February 27, 2018

CONSTRUCTION OF THE HWY 14 SENIOR/COMMUNITY CENTER

IFB#2018-0238-PW/IC

ADDENDUM No. 2

A1.0

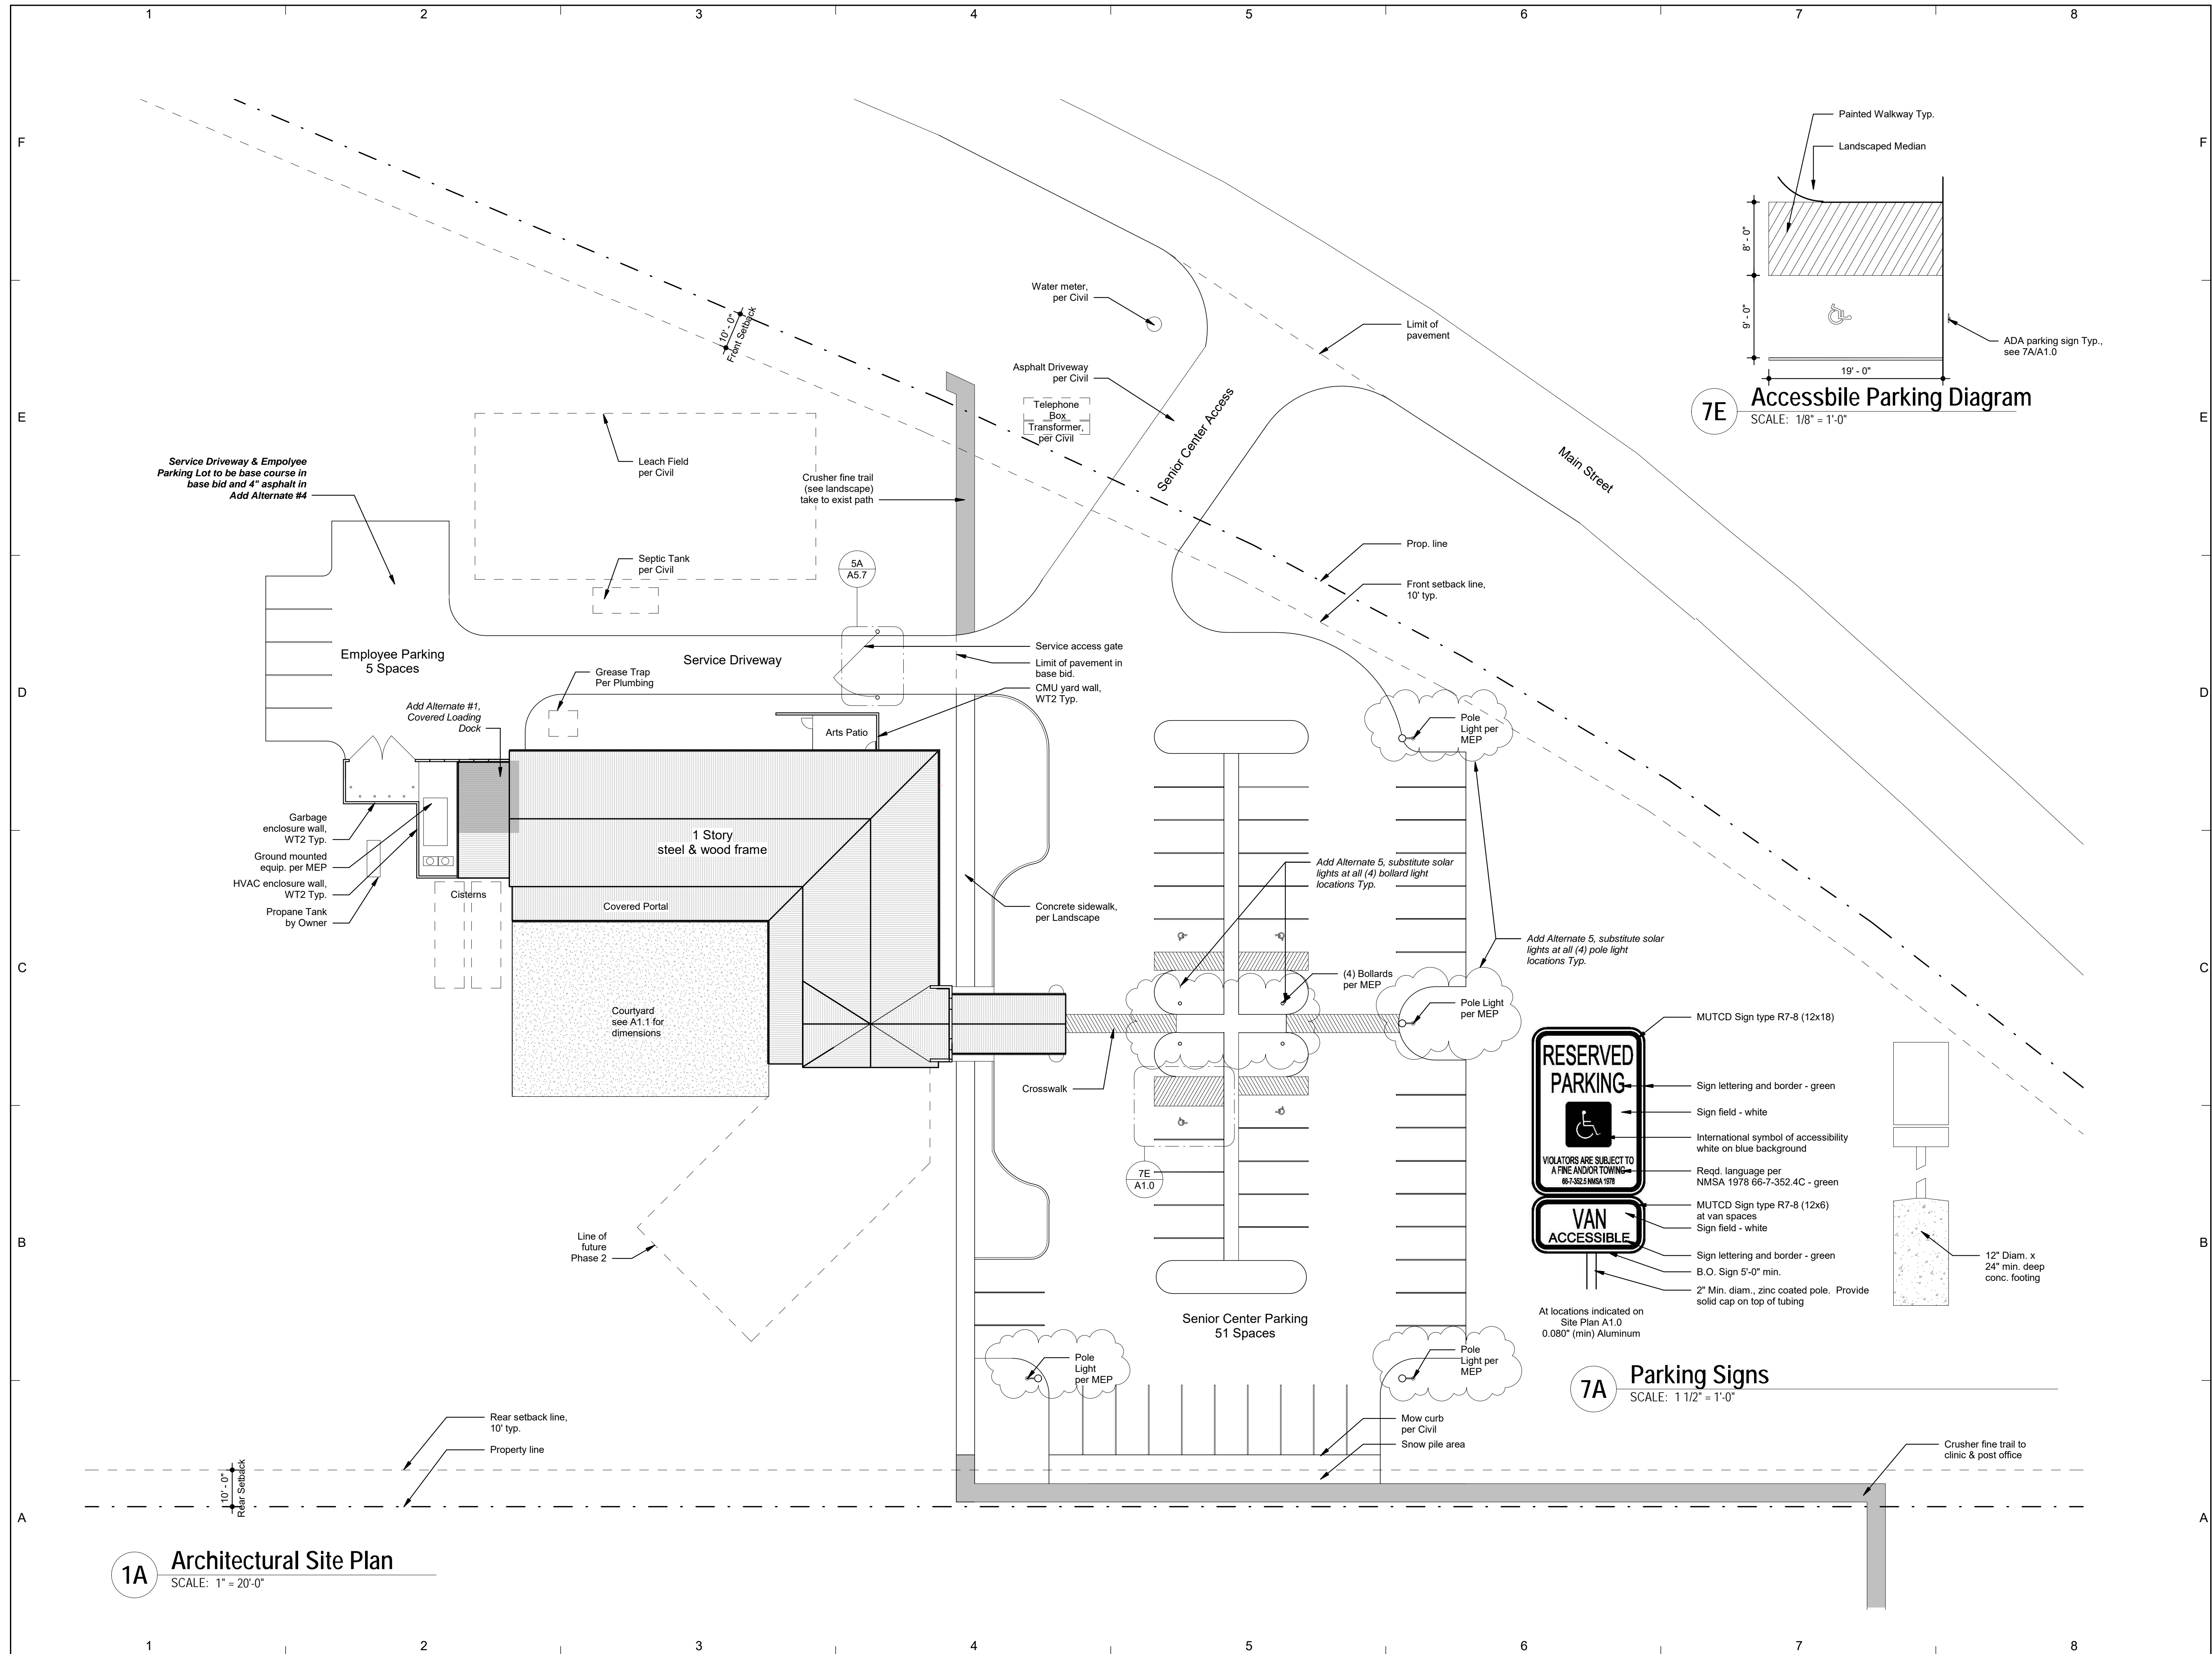
****ADD ALTERNATE NO. 5 (Item F on the revised bid sheet attached) has been added for solar Pole and Bollard lights in the parking lot as opposed to the hard wired system currently included in the base bid. Please see updated A1.0- Site Plan & A1.2- Floor Plan Alternates with clouded alternate (attached). ****

Question 1: Please provide a location for the Primary transformer that is going to power the Senior Center.

Question 2: Please provide a location for the Primary Telephone Pedestal? will local provider make the connection at the building or at the pedestal at property line?

Response 1: Please refer to A1.0 Site Plan for this information.

Response 2: It will be by the street and at the property line. Coordinate with CenturyLink. See A1.0 Site Plan.
